City of Portland Design Commission

DAR MEMO

Date: September 10, 2018
To: Portland Design Commission
From: Jill DeCoursey, Land Use Services
503.823.7314 | jill.decoursey@portlandoregon.gov
Bureau of Development Services | Portland, Oregon
Re: EA 18-216723 DA – 1431 N Church Street
Design Advice Request Commission Memo – September 20, 2018 Meeting Date

Killingsworth Station – Station Area Concepts from the North Interstate Corridor Plan

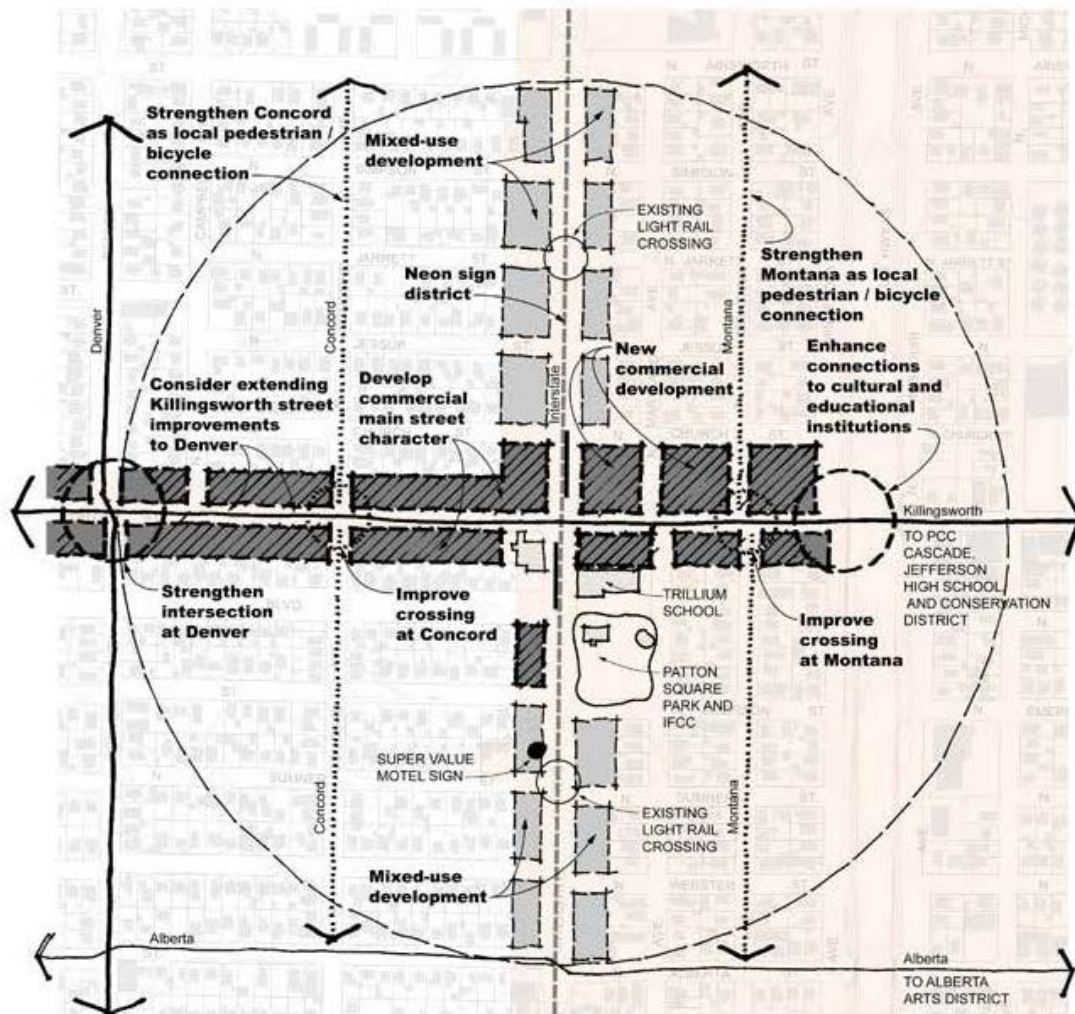
- a. The building's massing should better respond to its surrounding context.
- b. The project should also respond to the envisioned future context of the North Interstate Corridor Plan. (See Killingsworth Station Area Concept Plan below).
- c. The project site is adjacent to the Killingsworth MAX station. The proposal should do more to respond to this site condition.
- d. The project proposes large oriel projections on the west, south, and east sides of the building. Rather than overhanging the public realm, this area could be gained on-site with changes to the massing. Oriels could be appropriate on North Interstate, a significant City transit corridor.
